February 20, 2015
File No. 89220
Via Email and U.S. Mail

Town of Carlisle, Zoning Board of Appeals
ATTN. Steve Hinton
66 Westford Street
Carlisle, MA 01741
shinton@mindspring.com

**Re: Phase 1 Report
Independent Hydrogeologic Study
100 Long Ridge Road, Carlisle, MA**

ATTACHMENT C4

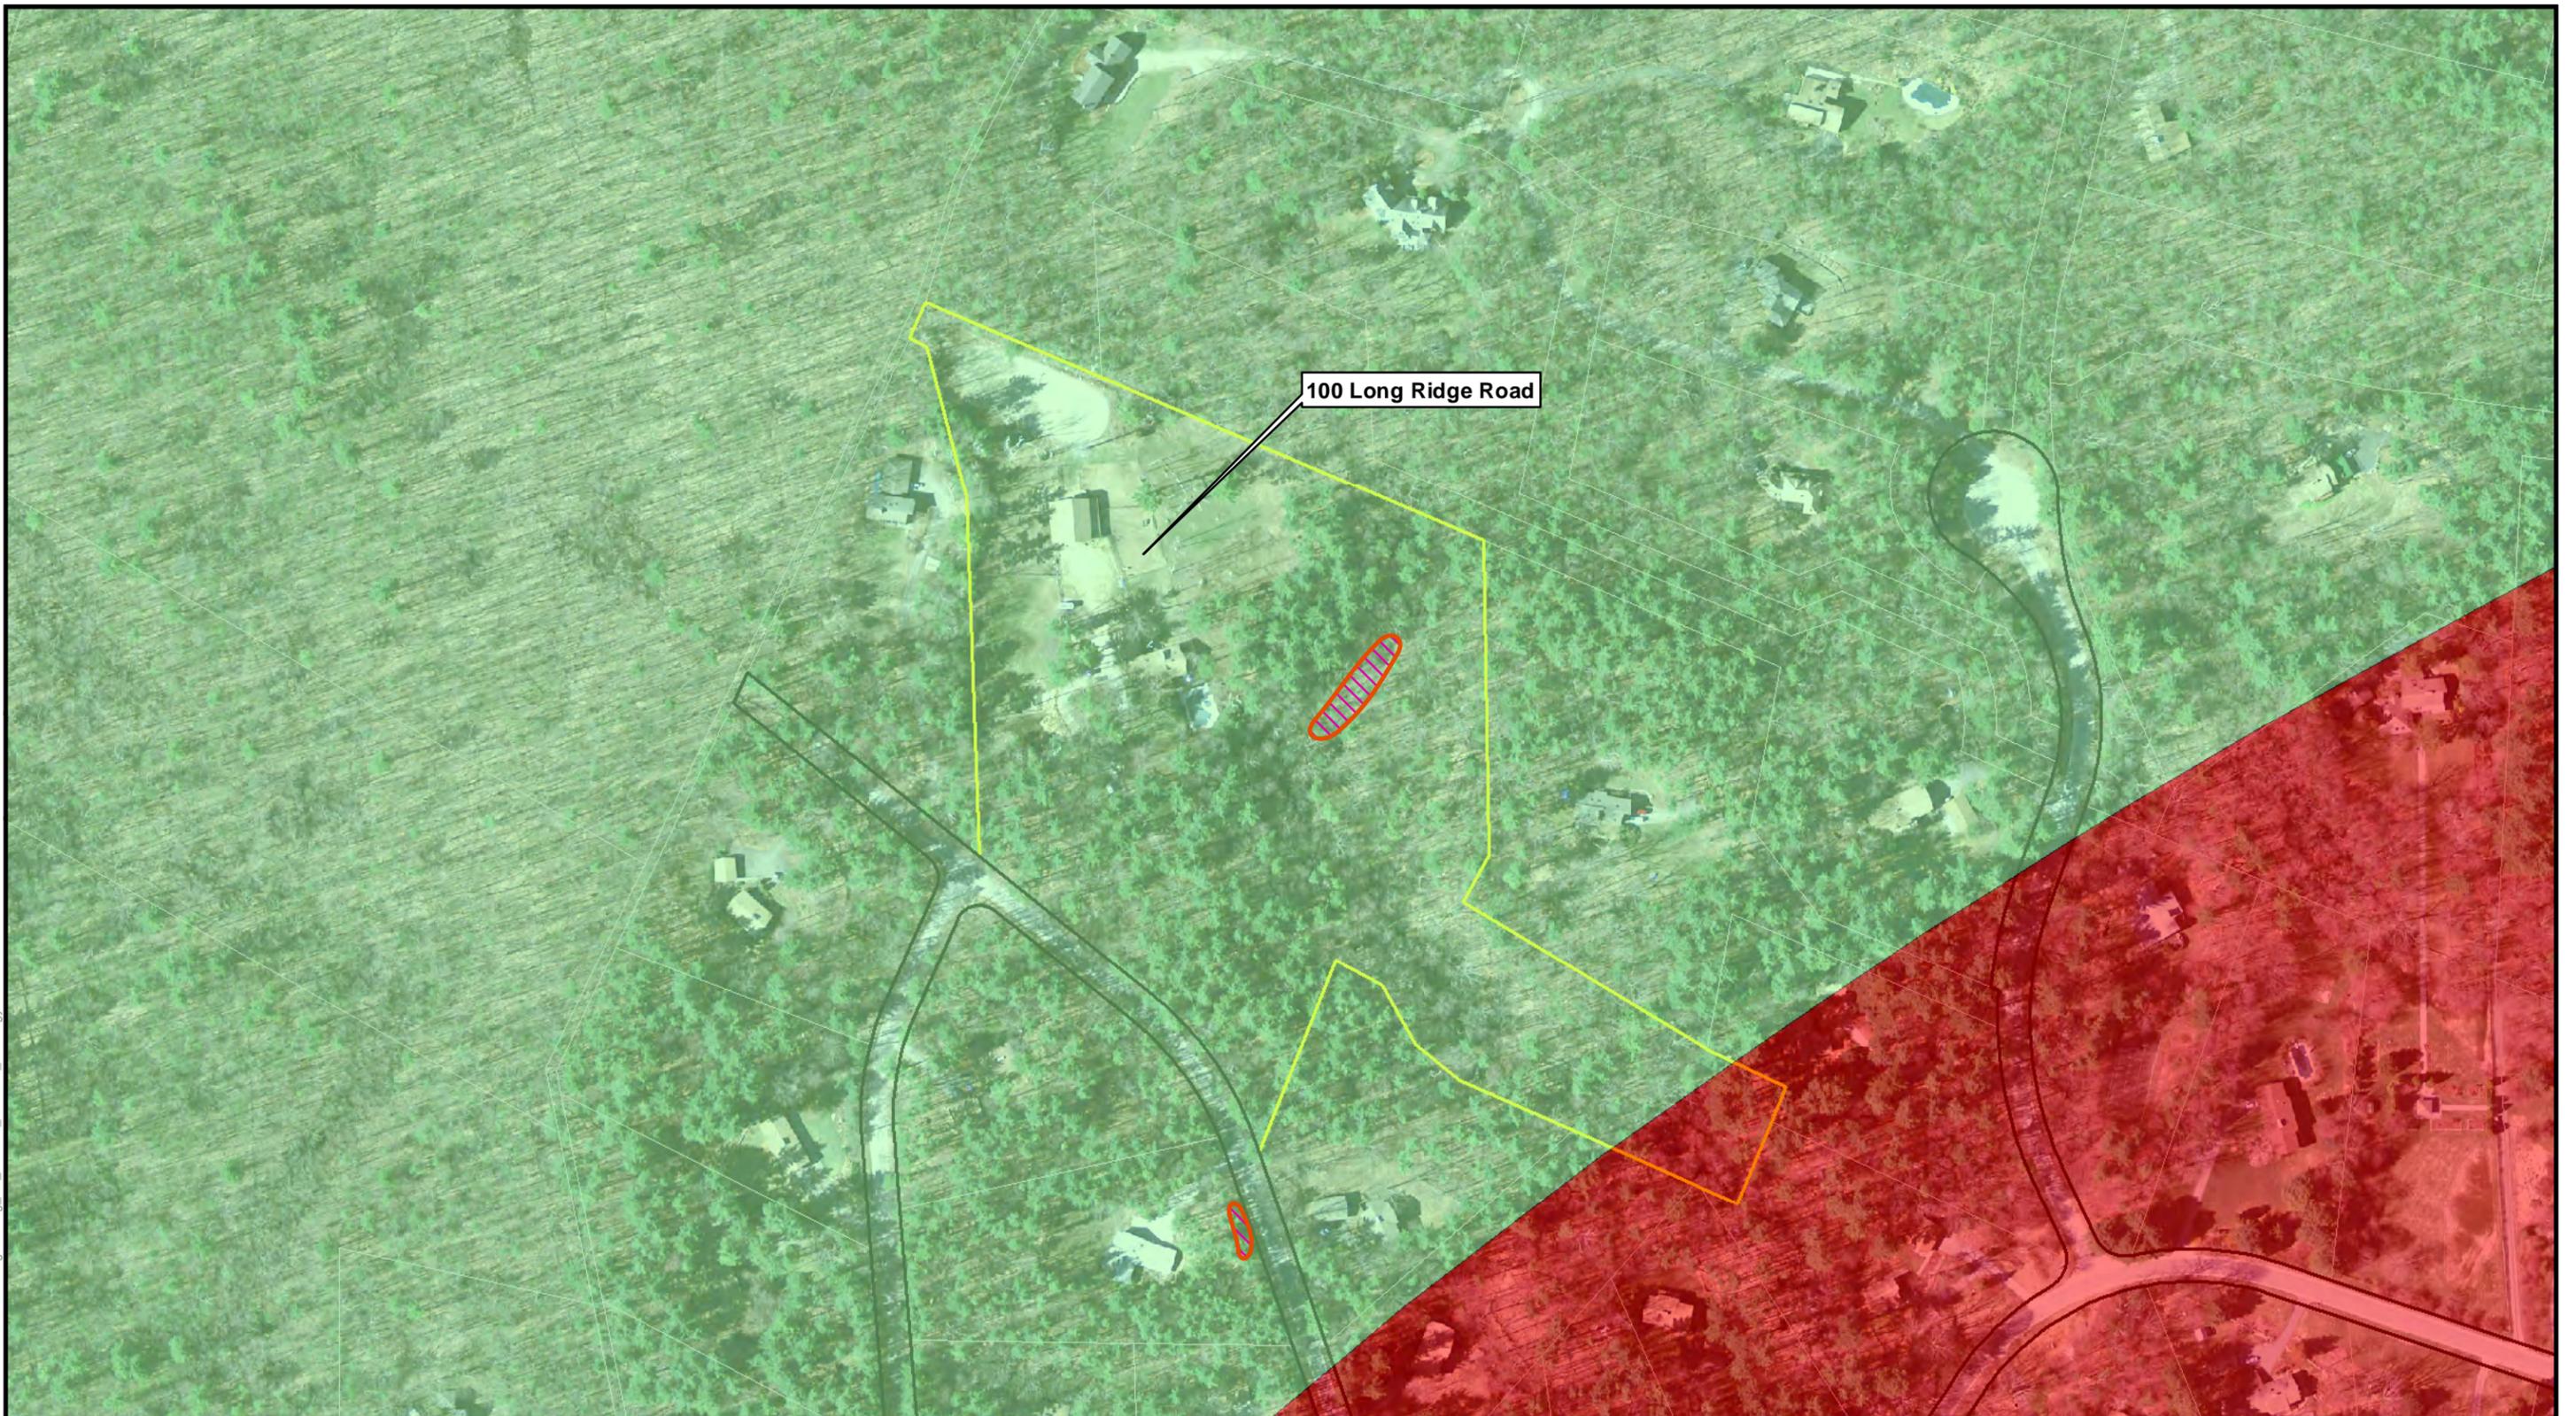
Bedrock mapping (Attachment C4) shows two primary lithologies in the area. Nearly all of the Site (and all of the area for the proposed development) is underlain by mafic rocks. Mafic rocks are dark rocks rich in magnesium and iron that may have had a volcanic origin, although they have since been metamorphosed (see more description below). Granite is mapped beneath the extreme southeastern corner of the Site; granite is a quartz-rich igneous rock. The bedrock lithology is important because lithology can influence fracturing (and thus transport pathways in the rock) and groundwater quality in the bedrock (and in drilled bedrock wells). Nobis proposes additional investigation of these considerations in Phase 2.

A wetland is present near the northern edge of the property, and wetland flagging was observed during the site walk. The wetland drains southward via a slow moving, reportedly ephemeral, brook that leads to another broad wetland in the extreme southeastern corner of the property. (See Attachment C3.) This brook/wetland complex transects the eastern portion of the Site and lies immediately east of the proposed development. A low, but steep ridge parallels the brook on the east side of the brook and is characterized by a long series of ridge-like bedrock outcrops. The outcrops trend northeastward (estimated to trend 30 to 40 degrees east of true north (N30-40E)) and are characterized by near vertical metamorphic foliations (layers) of the same trend. Some of these foliations appear to be fractured. Cross-cutting fractures are present but not common or prominent. Nobis did not collect any samples or take any measurements of the bedrock fractures or foliations. The rock appeared to be an amphibolite schist, consistent with the lithologic mapping illustrated in Attachment C4.

ATTACHMENT D

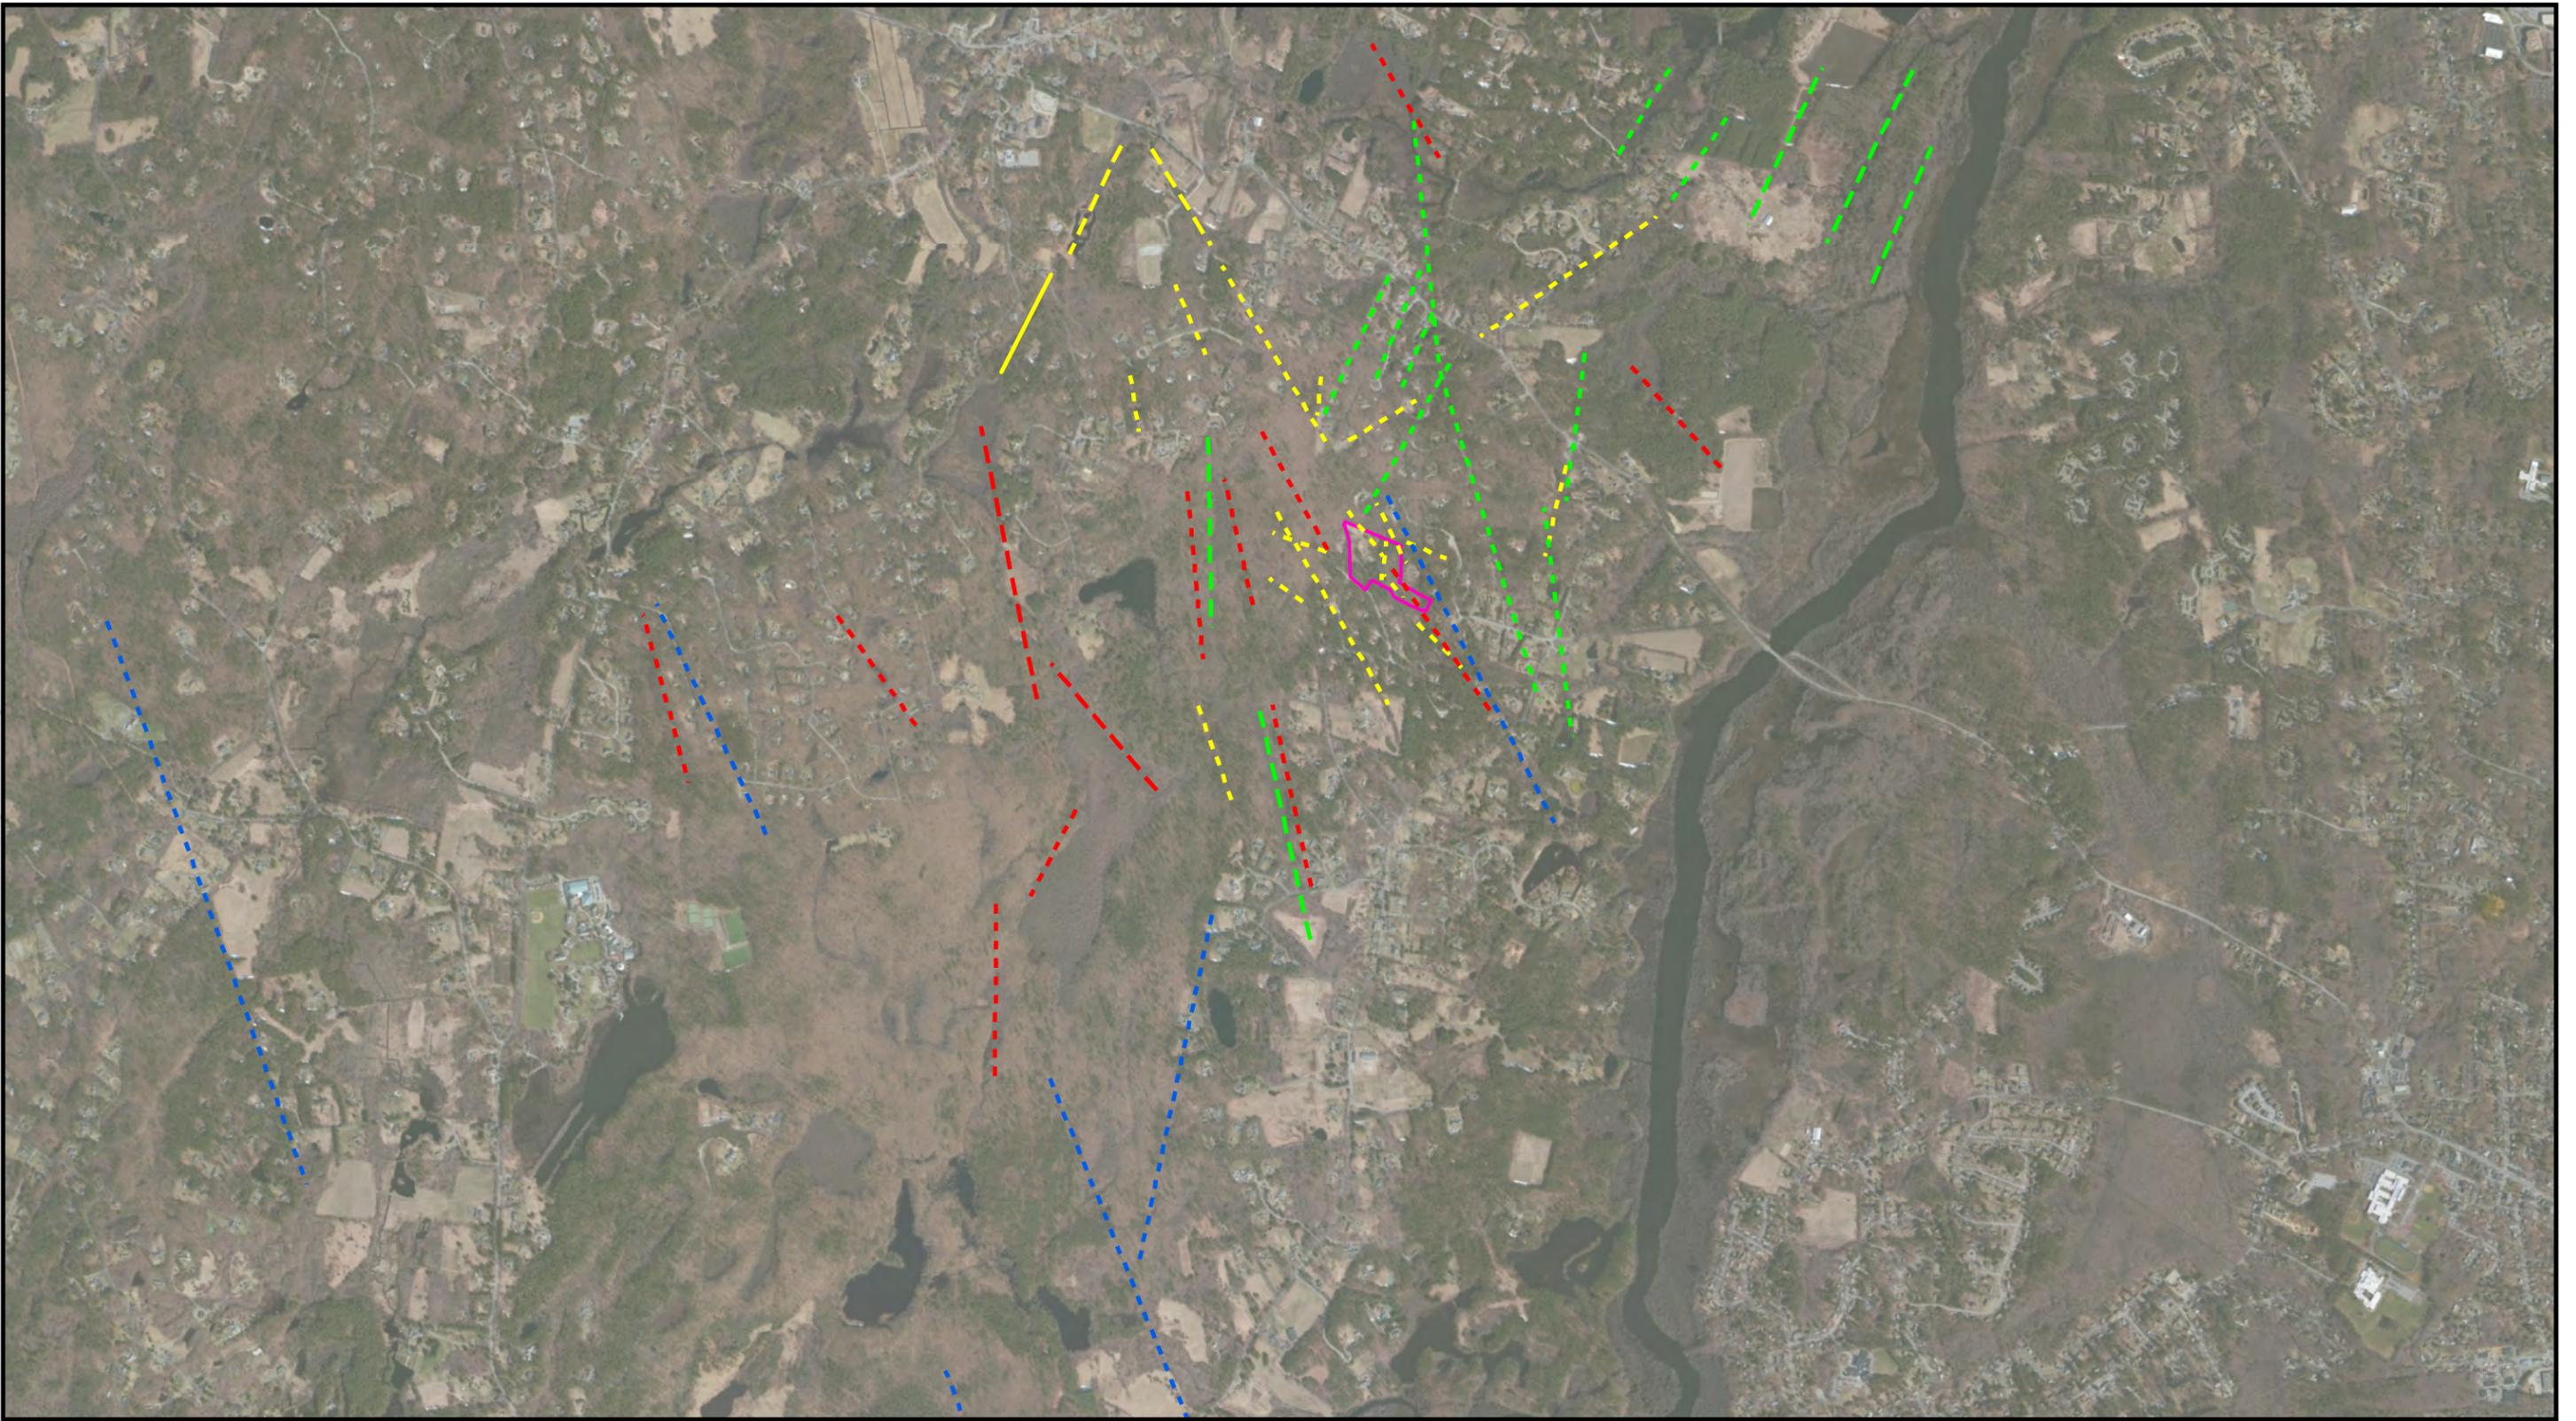
The results show that few strong or intermediate lineaments are present in the area (map in Attachment D) and that all the lineaments that occur on Site or on abutters' properties are subtle (Figure 3). The most common lineament orientation is northwest to southeast (NW/SE), although a north-northeast (NNE) trending lineament is present near the eastern edge of the Site. This lineament probably coincides with the brook, wetland, and northeast-trending outcrop in that location and may indicate that a steeply dipping bedrock fracture zone is present in this area. Such a fracture zone can potentially receive recharge from the overburden and soils that overlie it and can serve as a migration pathway for groundwater, possibly connecting bedrock wells with each other or with groundwater discharged at a septic disposal area.
